### REDUCTION OF ENTRANCE DOOR UNLOCKING TIME

Kit #287243 includes the following parts :

FIGURE 2: LOCATION OF MANIFOLD BEHIND DASHBOARD FINISHING PANEL

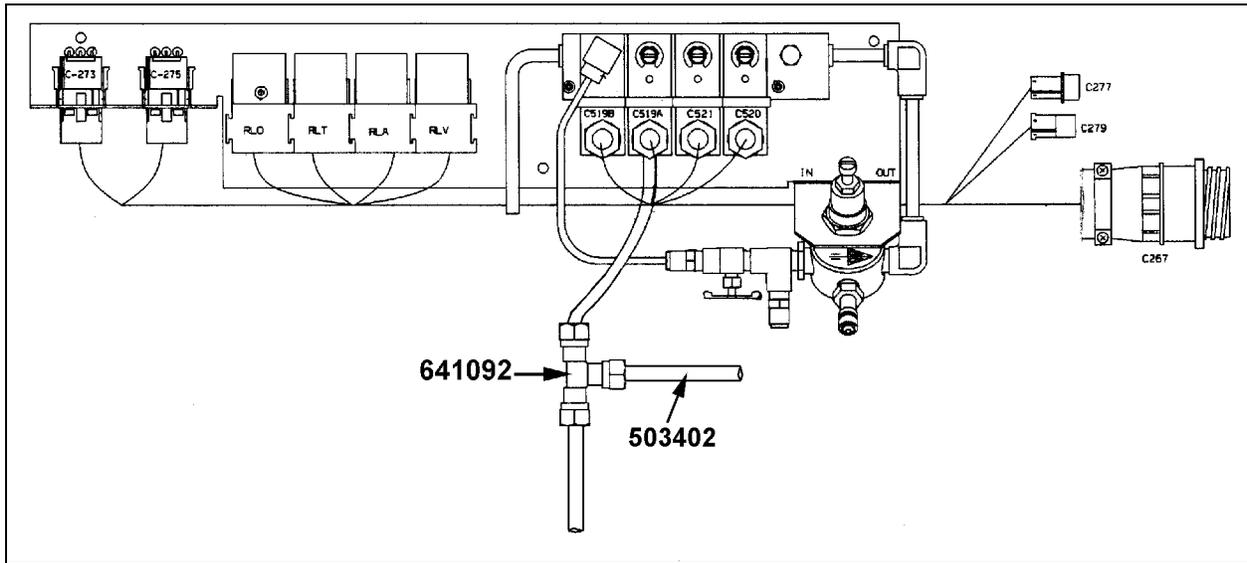
2. Locate entrance door manifold. Cut black nylon tube from C519A fitting. Connect a tee (Prévost #641092) between both ends of the black nylon tube.

3. Connect one end of the black nylon tube (Prévost #503402) to the tee then route the tube down towards the spare wheel compartment under the entrance steps.

FIGURE 3: ENTRANCE DOOR LOCKING CYLINDER

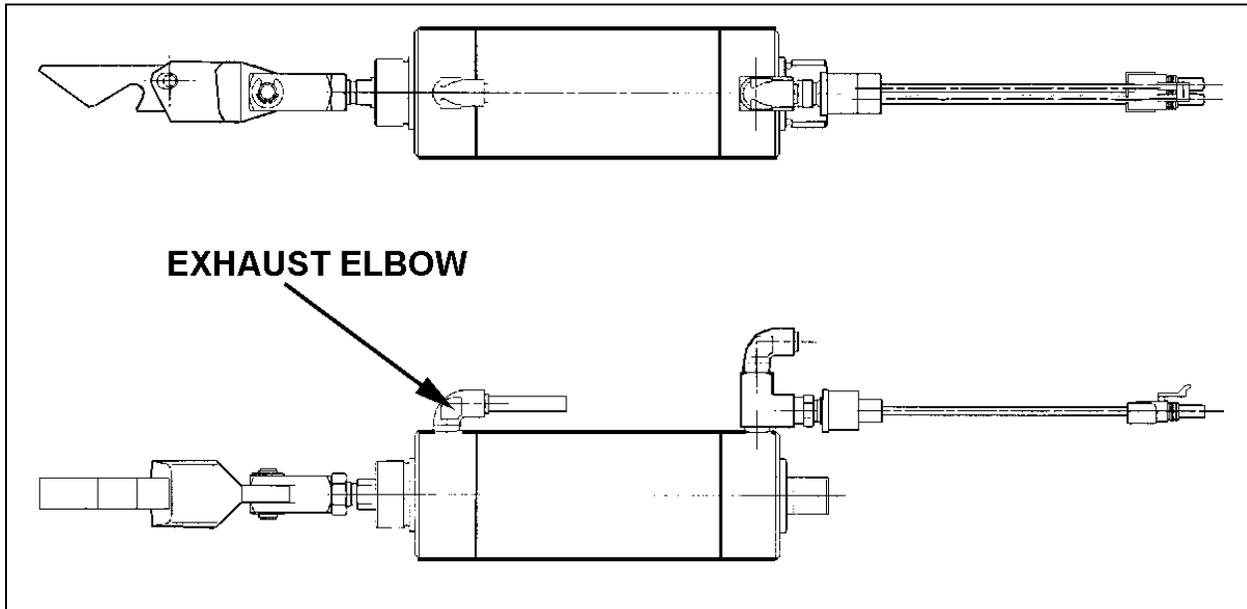
4. Remove finishing panel covering entrance door locking cylinder. Disconnect small tubing from cylinder exhaust elbow. Connect black nylon tube routed underneath the steps to the cylinder exhaust elbow.
